**IFB No. 17-26 Eisenhower Middle School HVAC and Roof Access Renovations**

**RE: ADDENDUM NO. 1**

Changes to Bidding Documents Dated January 13, 2017

PROJECT: EISENHOWER MIDDLE SCHOOL  
HVAC AND ROOF ACCESS RENOVATIONS  
ROCKFORD PUBLIC SCHOOLS 205  
ROCKFORD, ILLINOIS

ACCU-3

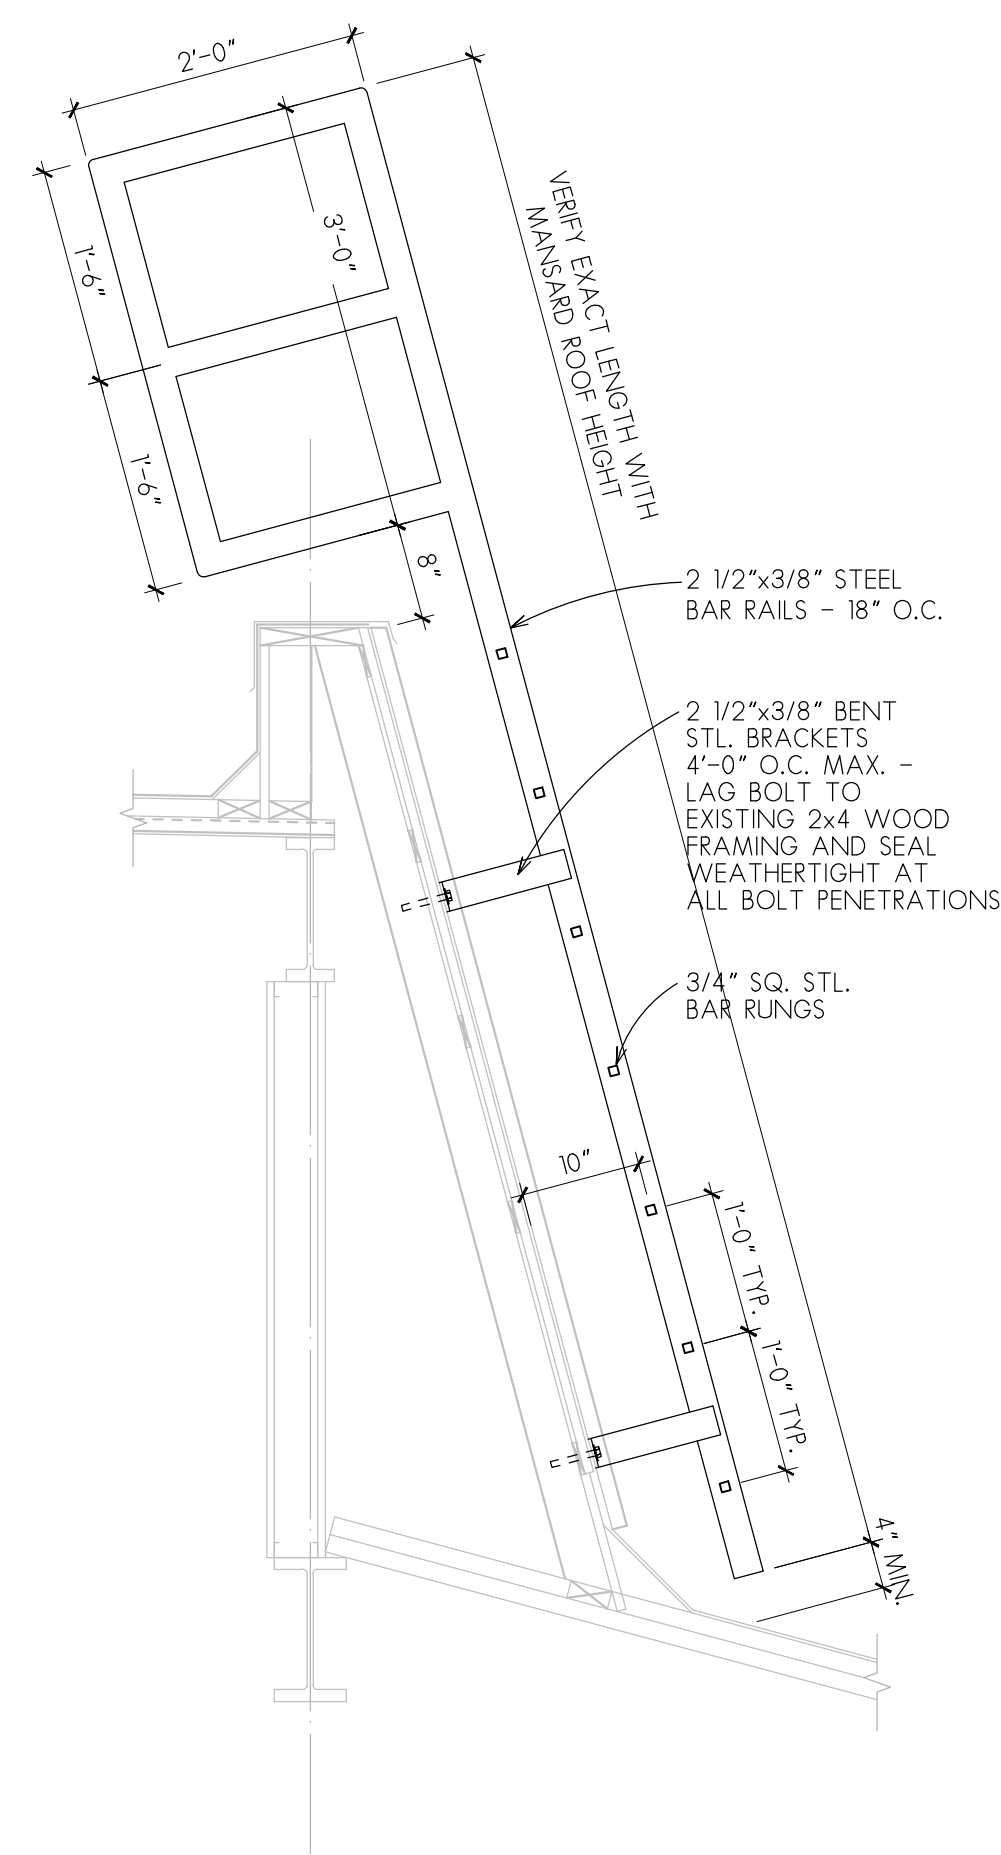
- 1. On Sheet M-1 states on Key Note 1 to provide additional structure as required (assume simple adding an angle across existing bar joists, etc.) for new ACCU's and Sheet MD1.1 indicates the existing condensing units to be removed. Are the existing curbs to be utilized and curb adapters used or are the existing curbs to be removed and new curbs installed?

***Existing units set on spring isolators and rubber pads. New units shall set on I-beams with angle channel bracing similar to recently replaced units. Refer to attached pictures.***

ISSUED FOR:	DATE
PROJECT NUMBER	25108
SHEET NUMBER	A4.1
DRAWN	APPROVED

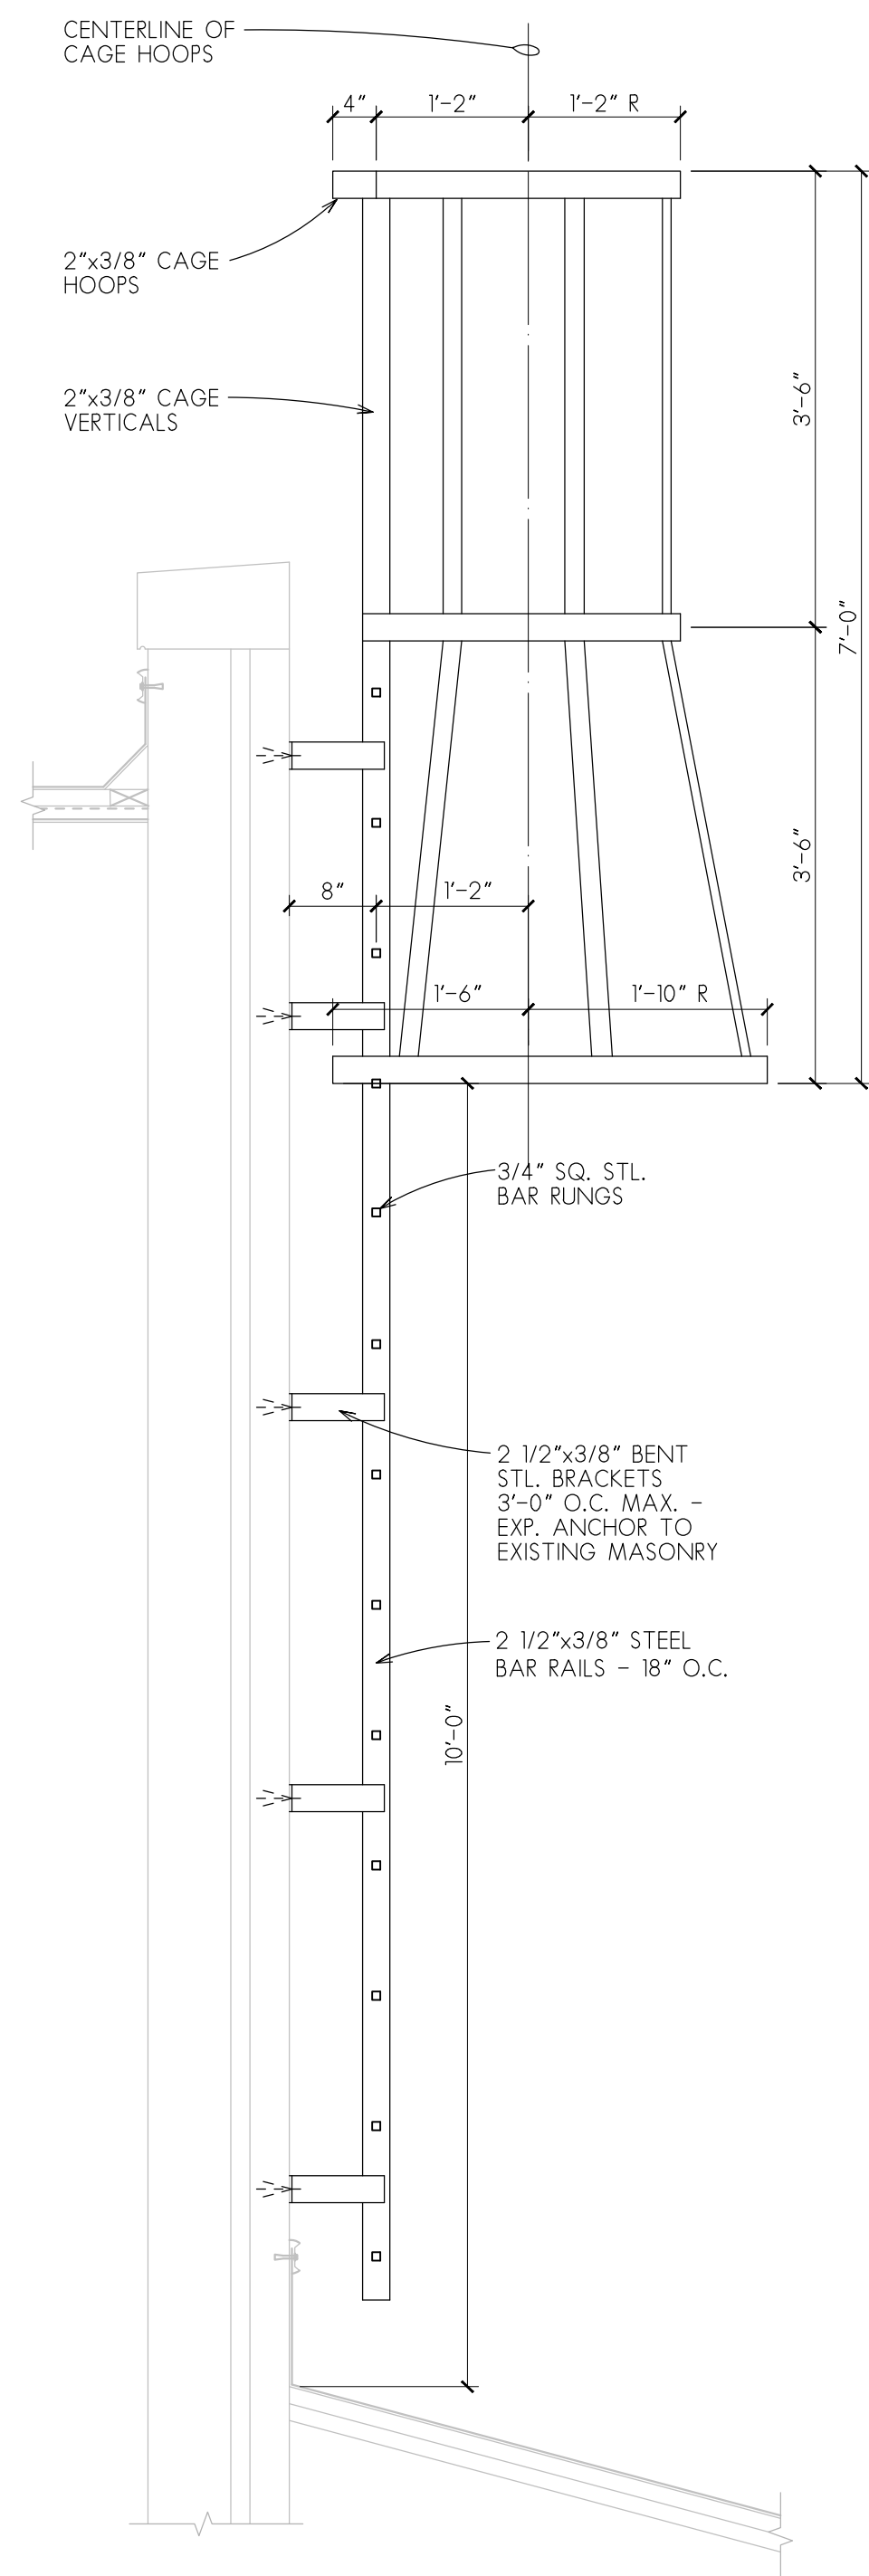
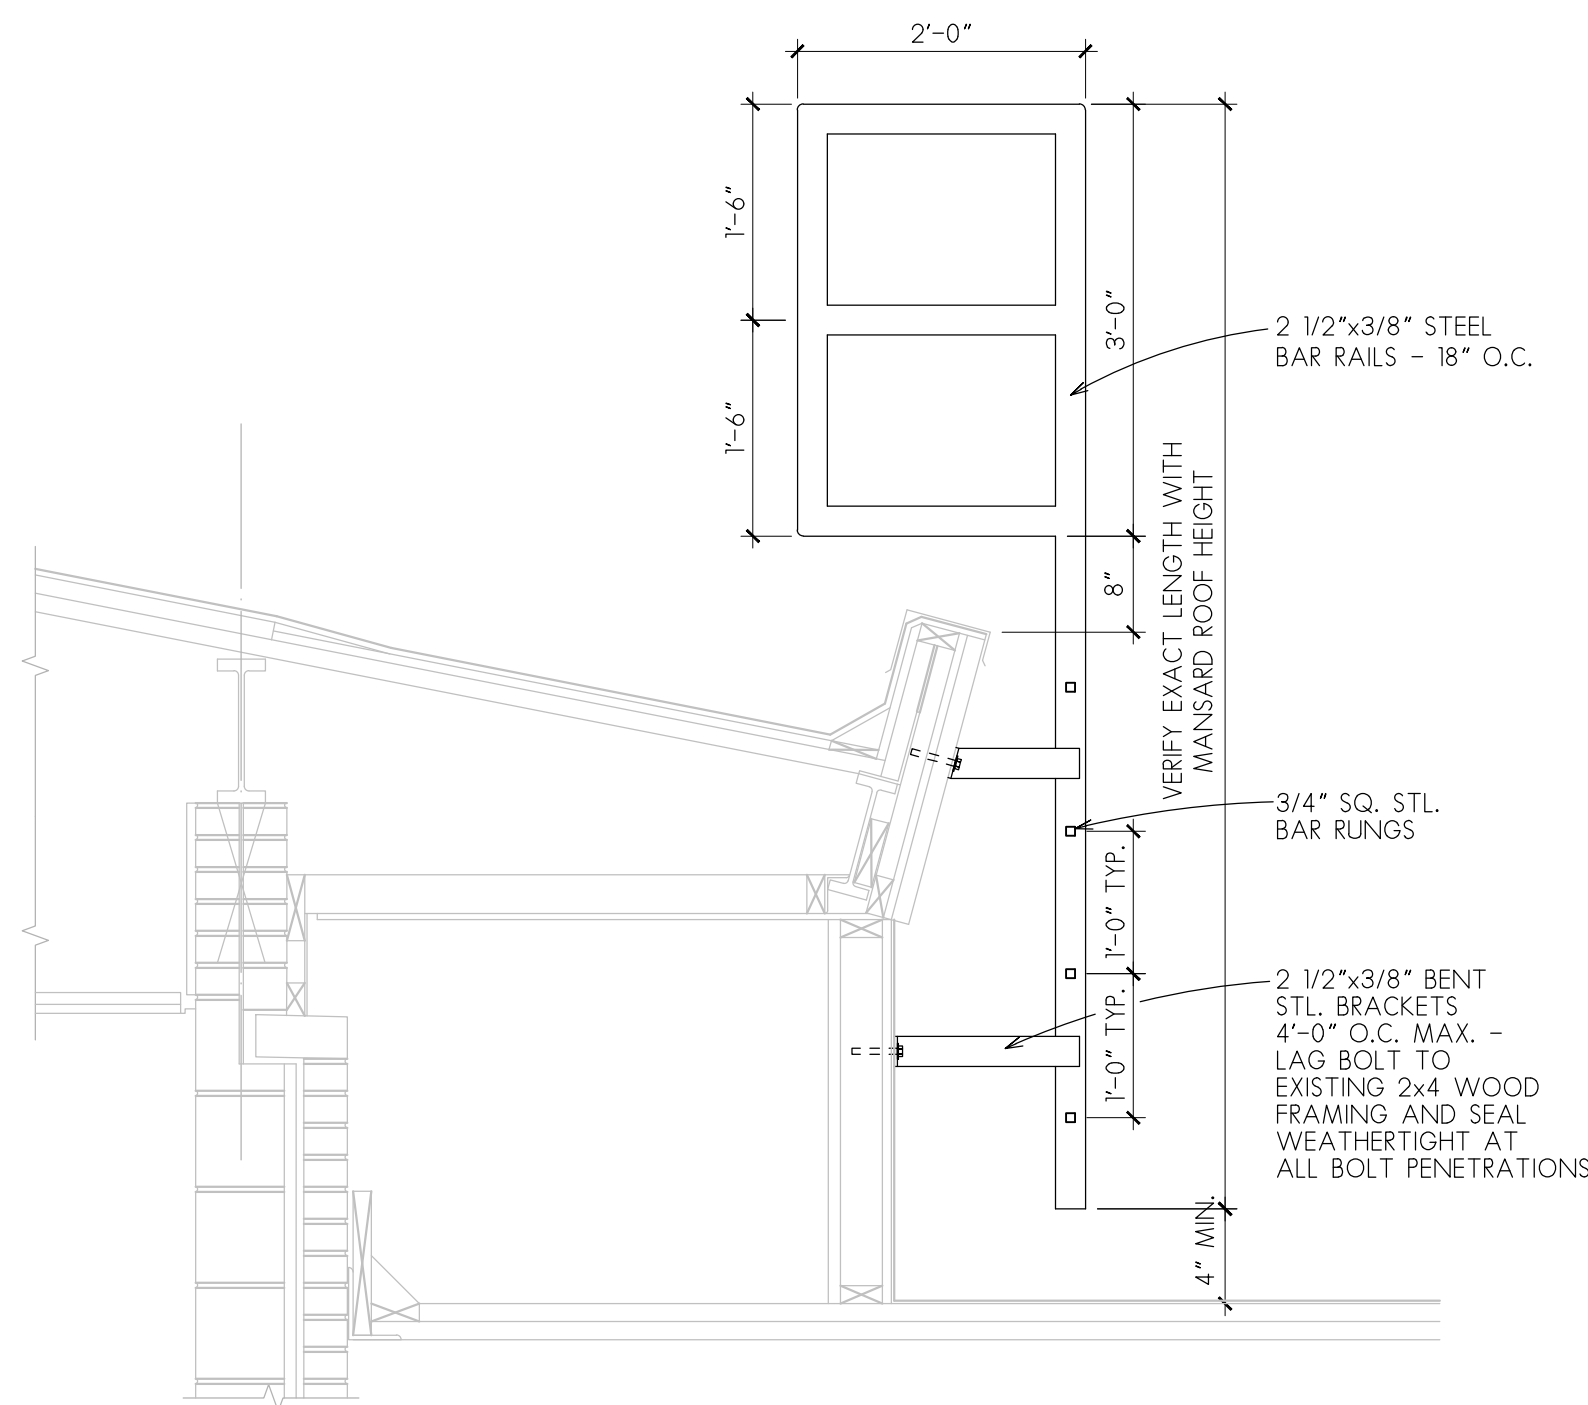
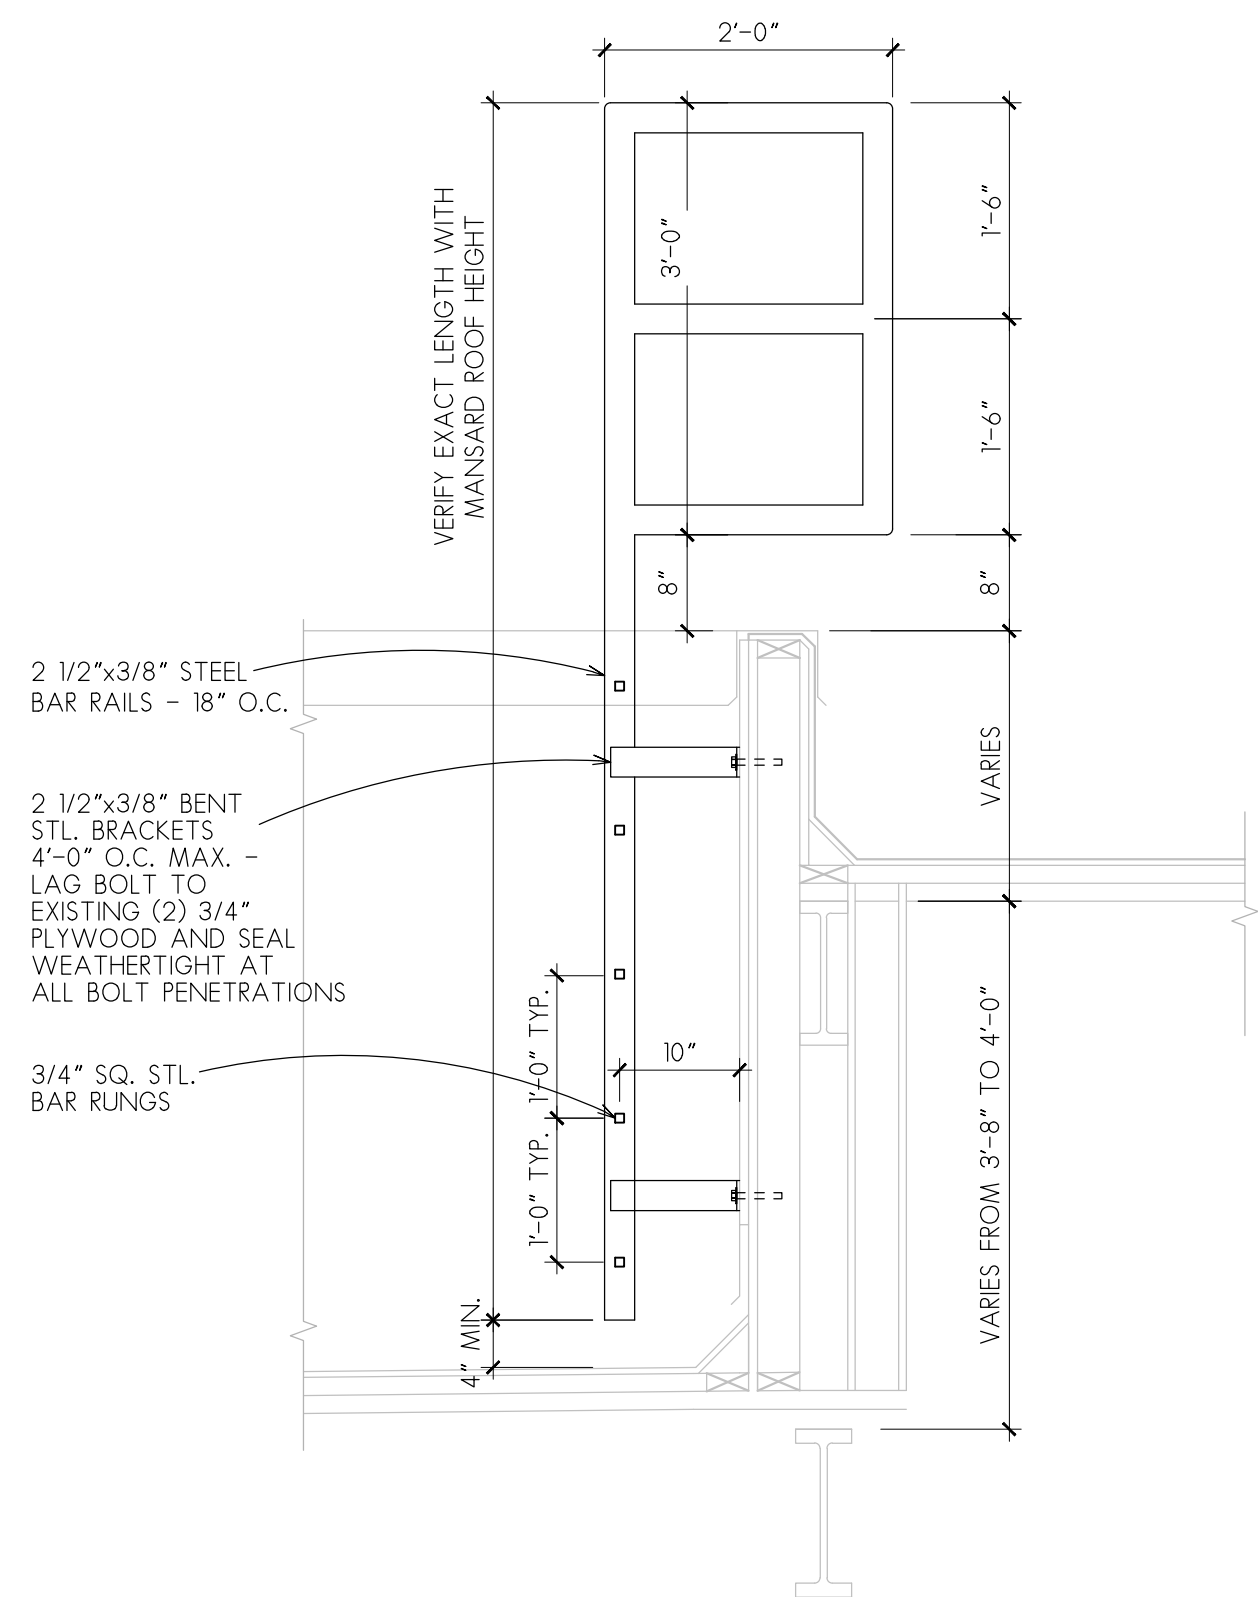
10. The 13'-6" floor to ceiling height requires a "deep box" vs. the "deep angle" stair that is detailed. The deep box (vertical section of stairway "inside the box") is what you show for the other six(6). The 13'-6" floor to ceiling height requires that the stairway be made 22" wide in lieu of the standard 30". This should be clarified or the other option may be to extend the framing down to "lower" the ceiling height. The "end" of the stairway is perpendicular to the doorway and ends into only what is probably open

11. The 10'-0" floor to ceiling height could allow a "deep angle" stair installed vs. the "deep box" shown. This would allow the stair to continue on an angle in lieu of having a vertical section at the top. Please clarify.

12. The stair box is shown to abut the mezzanine only at the top width (30") of the stair. There is no support for the stair box at the other three (3) sides. Will this arrangement support the stair? Is the deep box vertical section of the stair aligned with the beam placed this way to allow the box to be supported only along that edge?

***Refer to drawings A4.1 and A4.2.***

***Refer to drawings A4.1 and A4.2.***

***Refer to drawings A4.1 and A4.2***
